ADDENDUM 1

Wednesday, February 8, 2023

Project Name: ED 2 N 4th Floor Reno Rms 4223, 4224, 4225
Notice Number: PN22-106819

2 ENLARGED 4th FLOOR PLAN
SCALE: 1/4" = 1'-0"
TRUE NORTH PLAN NORTH

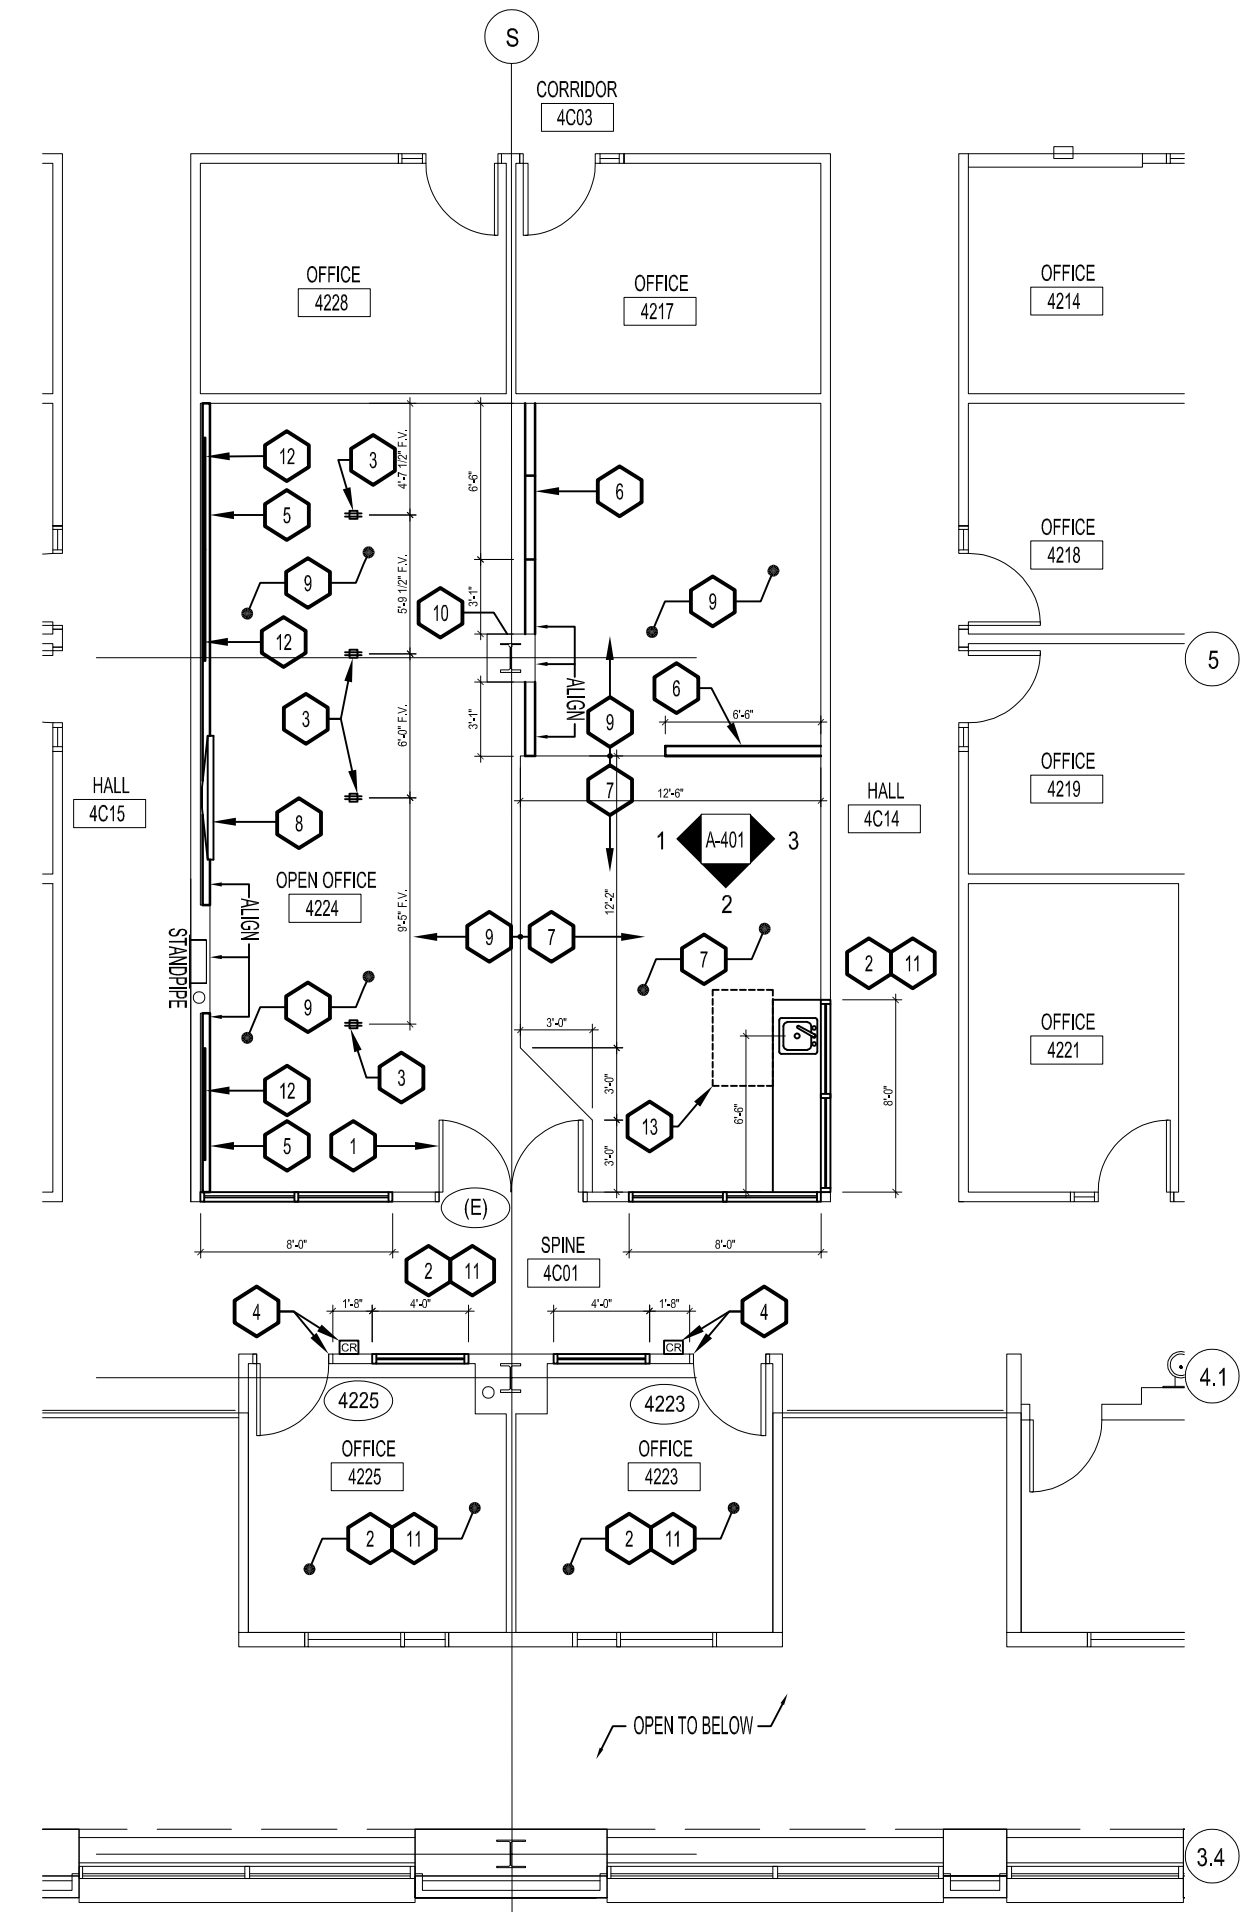
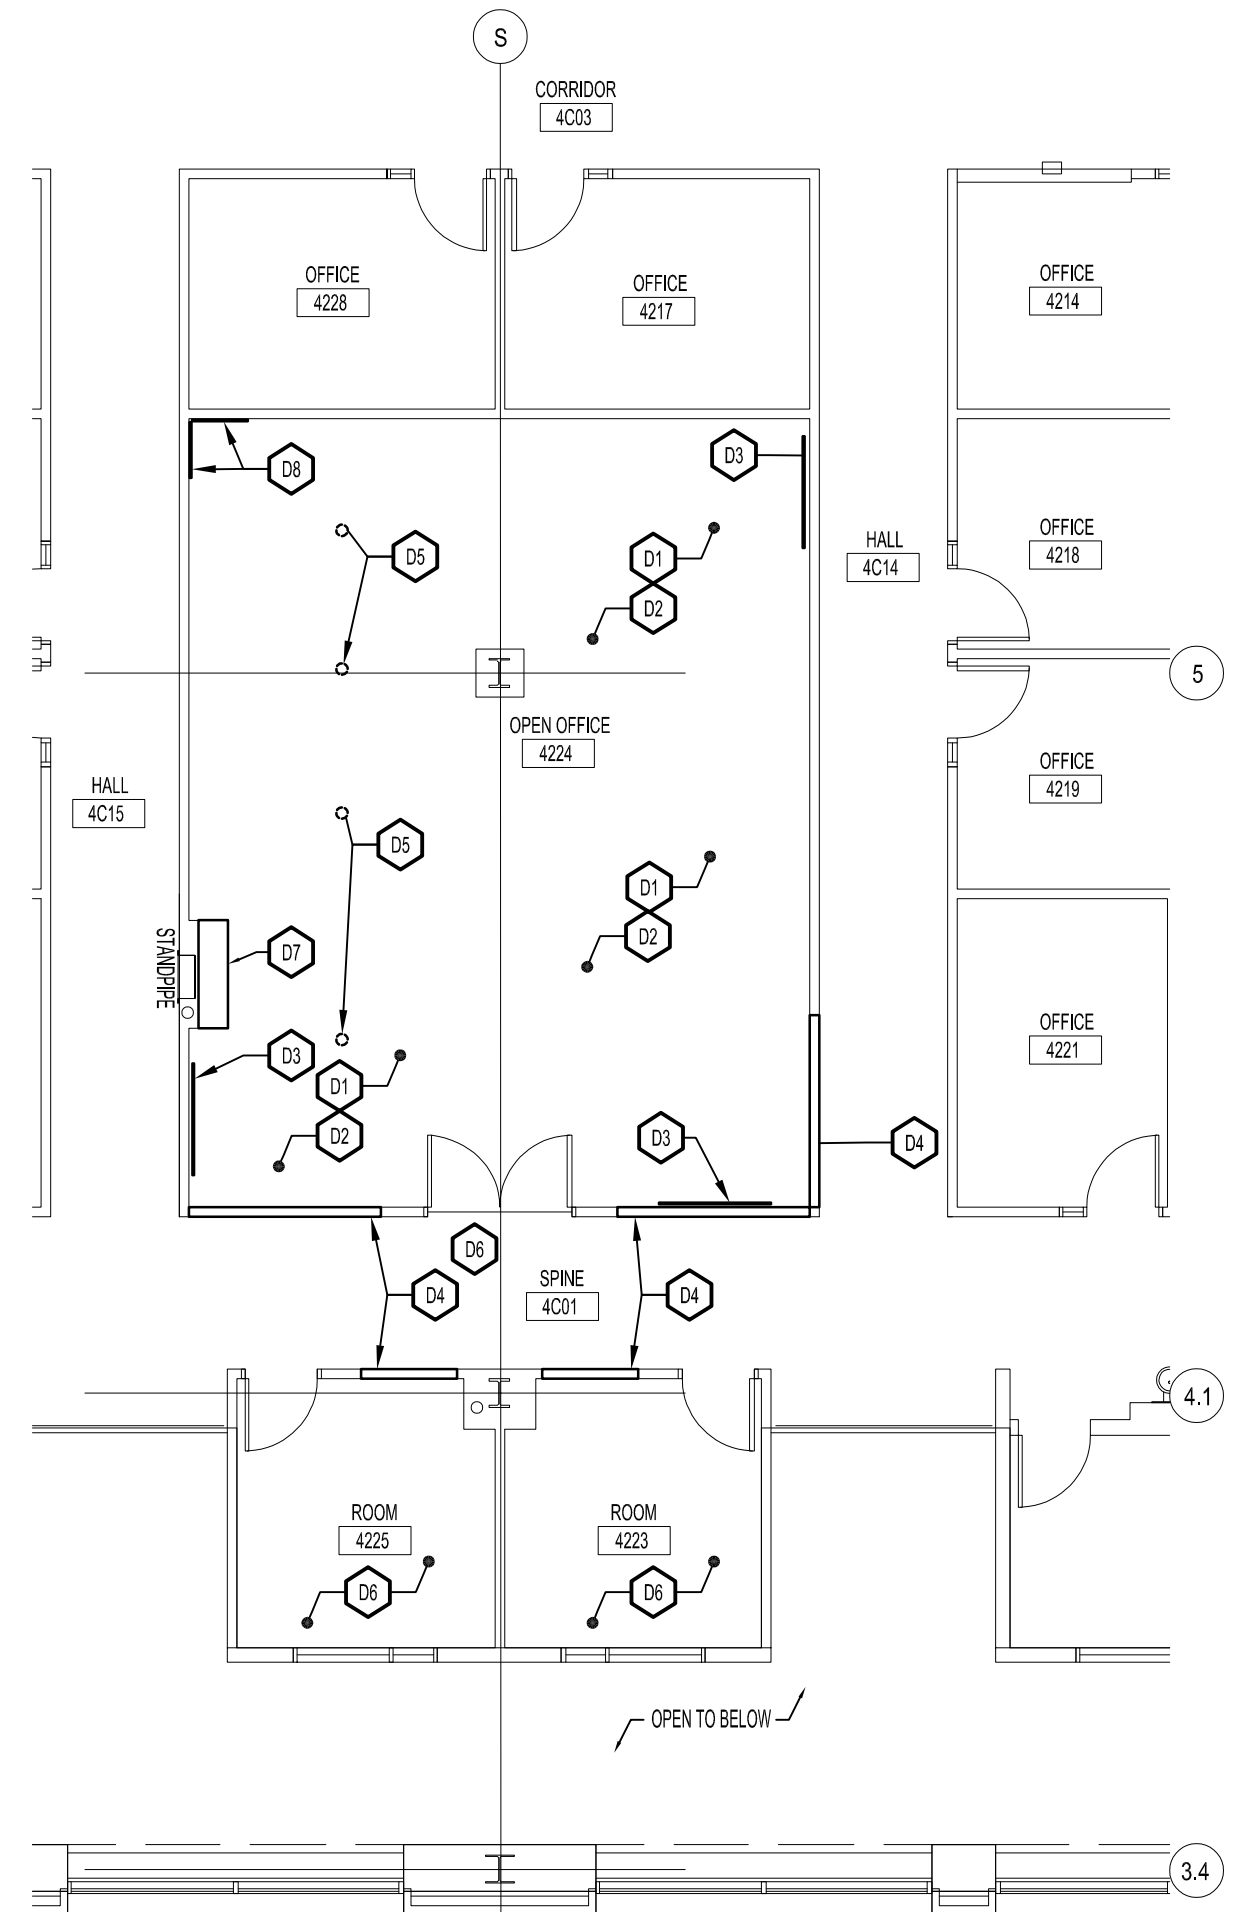
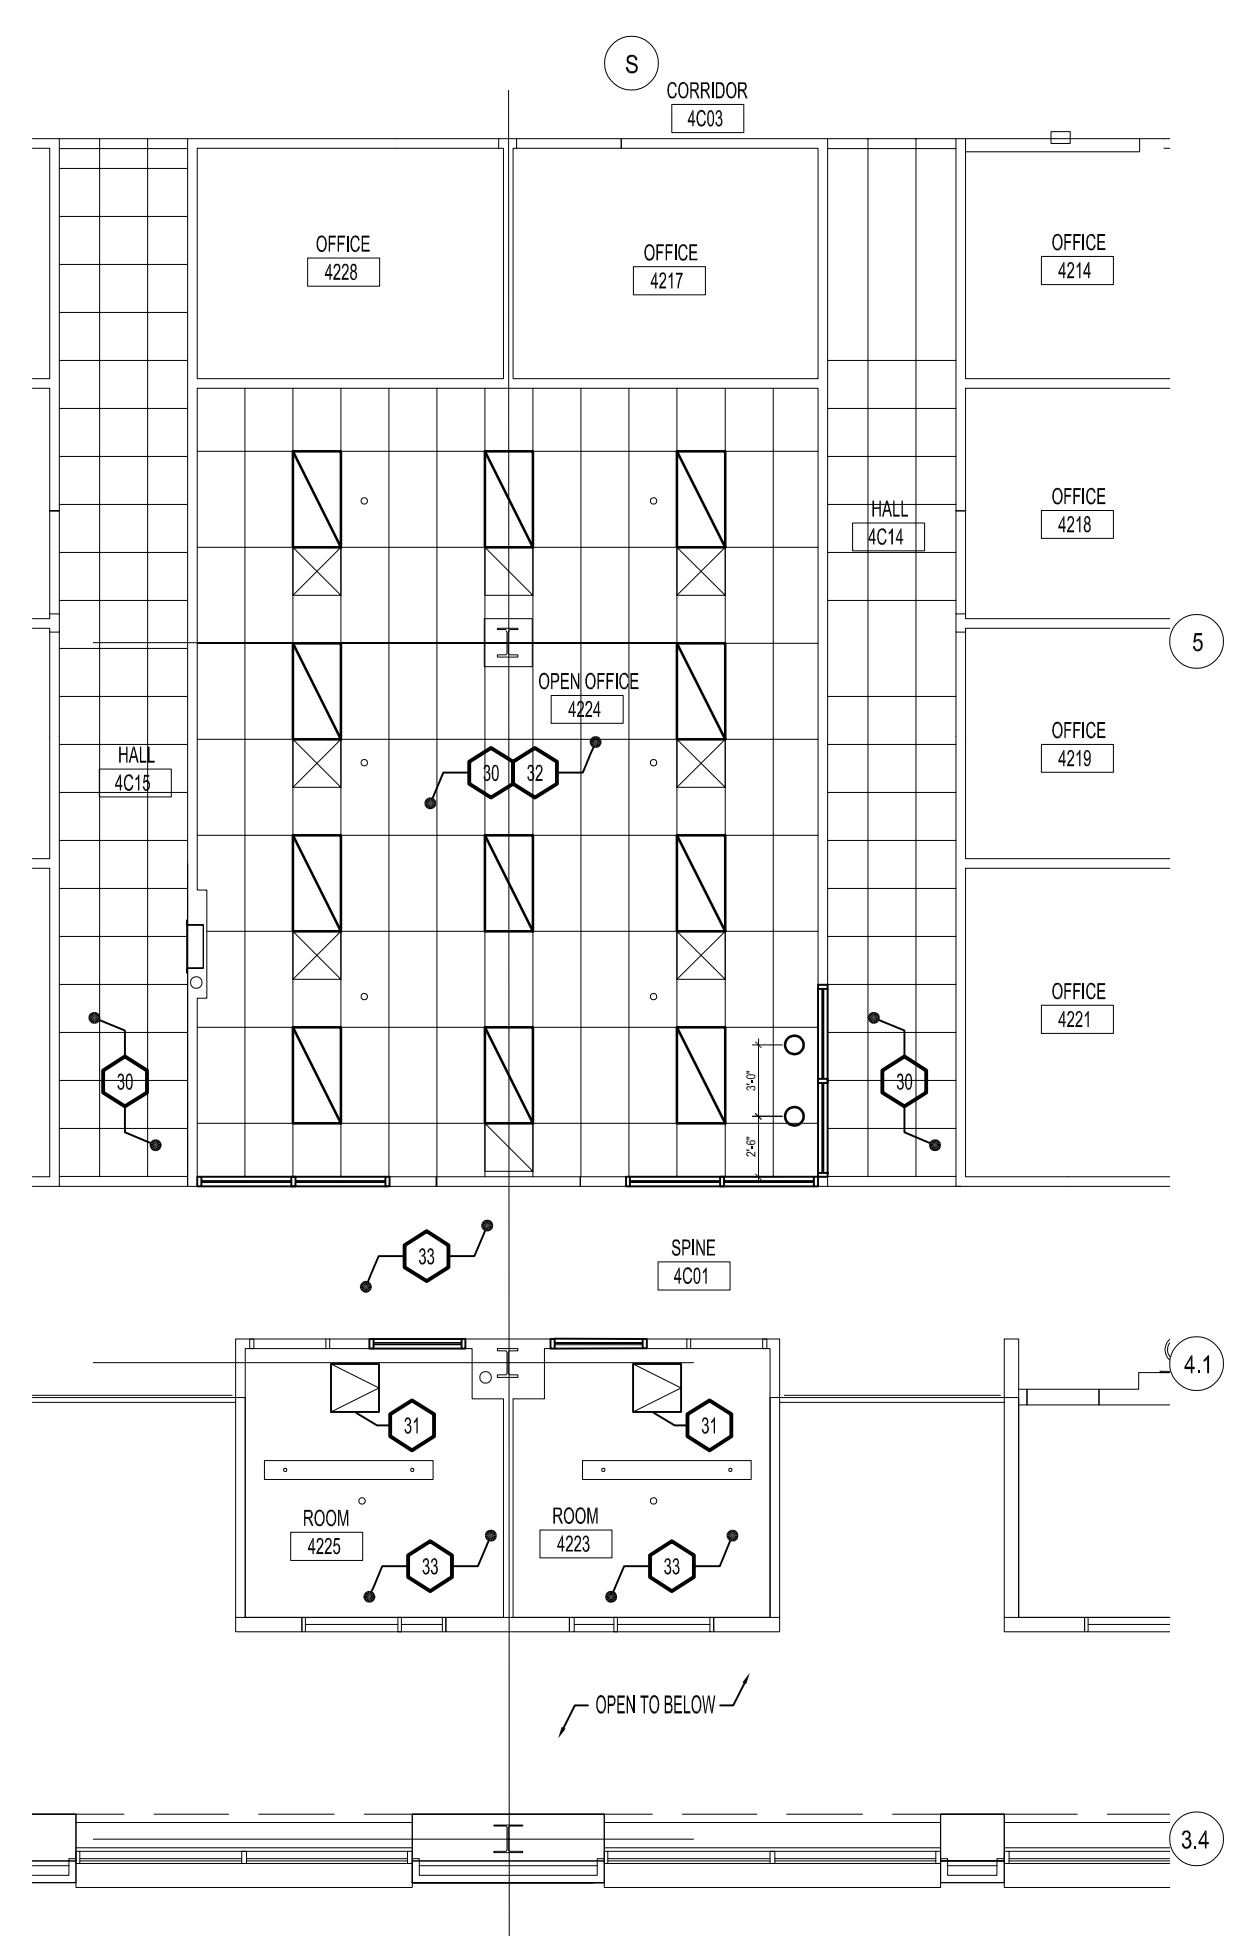
D1 - Sheet A-101: Keynote #8 updated. (SEE ATTACHMENT 2)

Q2 - Sheet A-101, floor plan keyed note #8: is there a preferred vendor for providing the listed A/V equipment? Please confirm that the general contractor is to include this work scope.

Q8 - Keynote 8 on plan 2/A-101 states A/V equipment is to be provided and installed by GC. Please confirm it is the client's preference to have this scope picked up by the GC rather than the owner.

Q14 - Keynotes 7 and 9 on plan 2/A-101 state wall base is TBD and there is no information in the spec. Please provide preferred manufacturer and product for wall base.

Answer- Drawings will be altered to remove this note. The A/V equipment purchase and installation will be the responsibility of CU and not the GC.

Answer- A/V equipment will be provided and installed by CU. Drawings will be changed.

- 8 MONITOR AND AV EQUIPMENT BY OWNER. G.C. TO PROVIDE PATHWAYS BACK BOXES AND POWER, RE: ELECTRICAL FOR ADDITIONAL INFORMATION.
- 9 PROVIDE & INSTALL NEW CARPET & WALL BASE, MANUFACTURER: TBD

7 TYPICAL INTERIOR HM WINDOW FRAME DETAIL

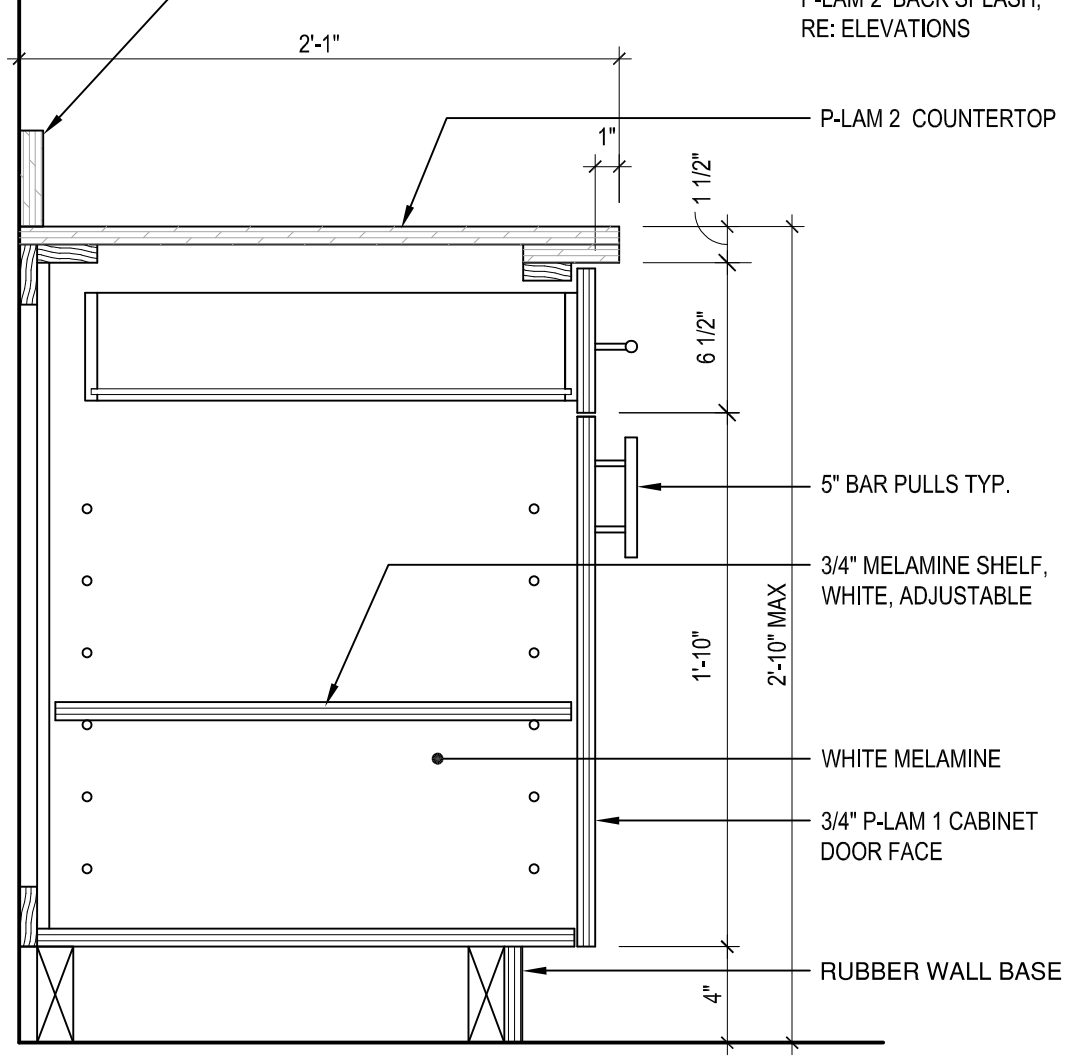
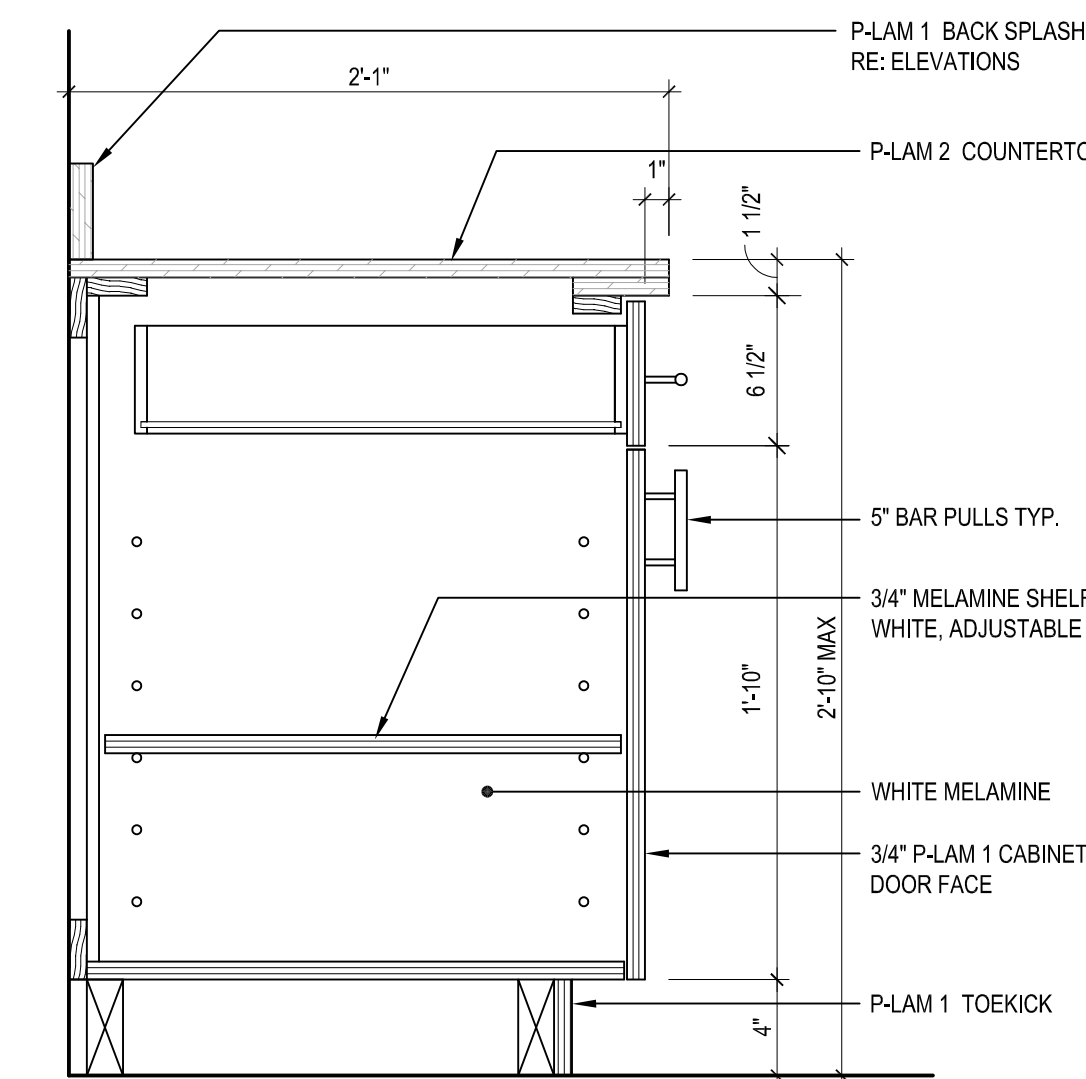
D2 - Sheet A-401: Finish schedule added, detail 7 updated to hollow metal detail, detail 5&6 P-LAM type corrected, and rubber base called out for finish kick. (SEE ATTACHMENT 3)
